III. Responses to Comments

A. Introduction

Thank you for the opportunity to comment on the Notice of Completion and Availability of the Draft Environmental Impact Report for the 6901 Santa Monica Boulevard Mixed-Use Project (Project) located at 1100–1126 Orange Drive; 6906–6931 Santa Monica Boulevard; and 1107–1121 Mansfield Avenue in the City of Los Angeles. This letter conveys recommendations from the Los Angeles County Metropolitan Transportation Authority (Metro) Concerning issues that are germane to our agency’s statutory responsibility in relation to our facilities and services that may be affected by the proposed project.

Figure 4: 2014 Statewide All Fleet Sizes (Pieces of Equipment)

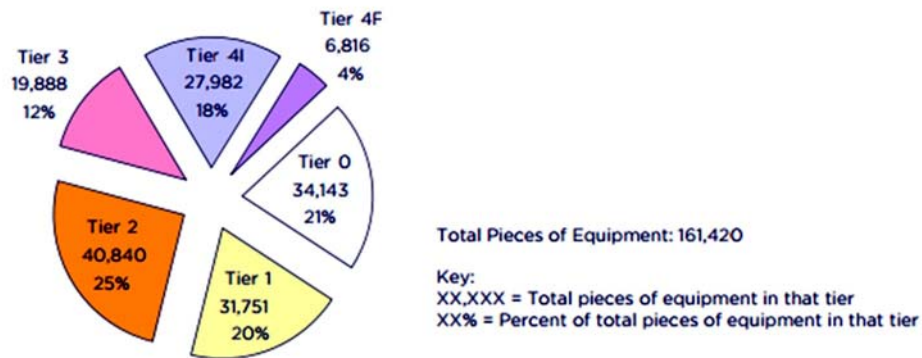
Furthermore, based on information and data provided in the *San Francisco Clean Construction Ordinance Implementation Guide for San Francisco Public Projects*, the availability of Tier 4 Final equipment is extremely limited. In 2014, 25% of all off-road equipment in the state of California were equipped with Tier 2 engines, approximately 12% were equipped with Tier 3 engines, approximately 18% were equipped with Tier 4 Interim engines, and only 4% were equipped with Tier 4 Final engines (see excerpt below).¹⁸

As demonstrated in the figure above, Tier 4 Final equipment only accounts for 4% of all off-road equipment currently available in the state of California. Thus, by stating that the Project proposes to use Tier 4 Final equipment during construction, the DEIR is relying on a fleet of construction equipment that only accounts for 4% of all off-road equipment currently available in the state of California. Therefore, by failing to evaluate the feasibility of implementing Tier 4 Final engines into the Project's construction phases, the Project's construction emissions are underestimated. For these reasons, we find the DEIR's air pollution model to be incorrect and should not be relied upon to determine Project significance.

Failure to Consider Impacts from Other Projects Within the Area

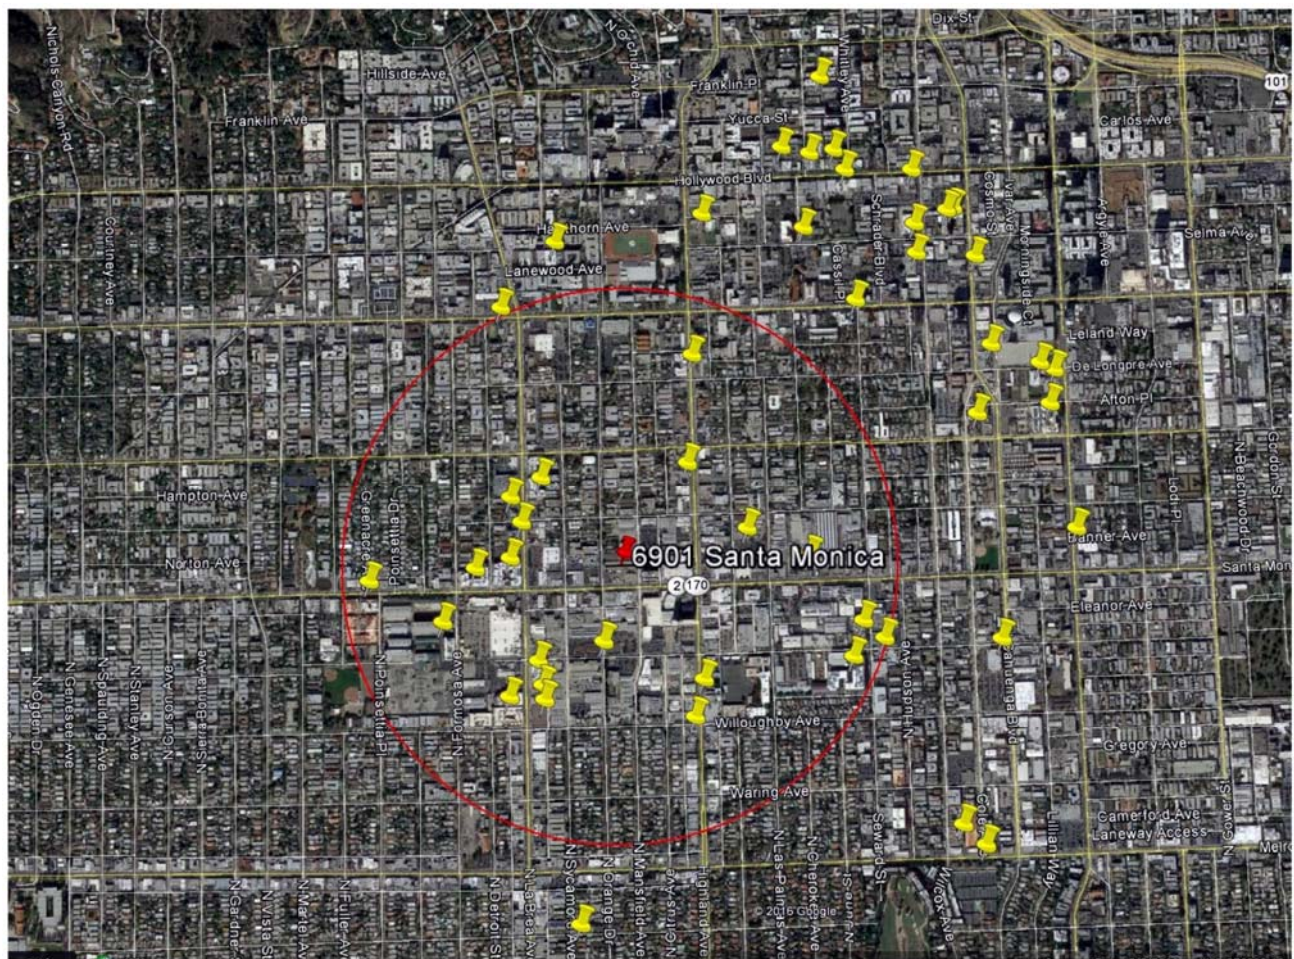
The DEIR fails to account for impacts from other development projects within the area. As a result, the Project’s incremental increase in criteria air pollutant emissions within the area, as well as its cumulative air quality impact, are misrepresented.

The DEIR identifies a total of 118 related projects within the affected Project area that are or will become operational (and thus will produce pollutant emissions) around the same time as the proposed Project (Table 3-1, pp. 96–101). However, the DEIR fails to actually evaluate the cumulative air quality impacts that the Project, in combination with these 118 related projects, would result in. The DEIR attempts to justify this omission of a proper analysis by stating that “individual projects that generate emissions not in excess of SCAQMD’s significance thresholds would not contribute considerably to any potential cumulative impact” (p. 4.C-20). Therefore, since the DEIR’s air model found the Project’s individual construction and operational emissions to be less than significant, the DEIR concludes that the Project’s construction and long-term operational emissions would not result in a cumulatively considerable impact (p. 4.C-22). This conclusion, however, as well as the justification provided to support this conclusion, are inadequate, as they do not actually evaluate or quantify the Project’s cumulative impacts. According to CEQA Guidelines Section 15355, “Cumulative impacts” refers to two or more individual effects which, when considered together, are considerable or which compound or increase other environmental impacts”.²² Therefore, the DEIR’s assertion that the Project would not have a cumulatively significant impact on air quality is completely unsubstantiated, as the DEIR fails to consider the combined emissions resulting from the proposed Project and the other proposed Projects within the area. Furthermore, according to Section 15064(h)(1) of the CEQA Guidelines,
